September 22, 2022

Version 3

## MIL Is ON with DTC P0455

Supersedes 21-007, dated September 2, 2022, to revise information highlighted in **yellow**.

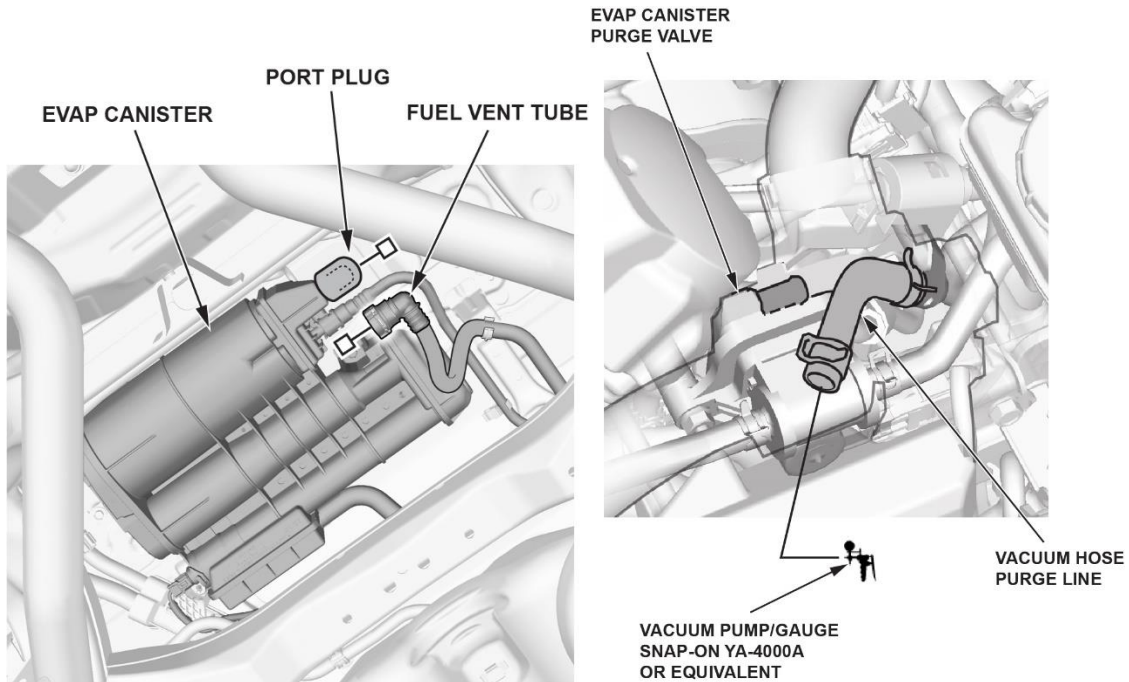
Under INSPECTION PROCEDURE, steps 6 and 10 were revised.

9. Select CVS ON and apply vacuum to the hose until it reads **1.90 V**.

10. Go to the PGM-FI data list and monitor the FTP sensor voltage.

- If the FTP sensor voltage does not increase more than **0.2 V**, the system is normal. Go to step 11.
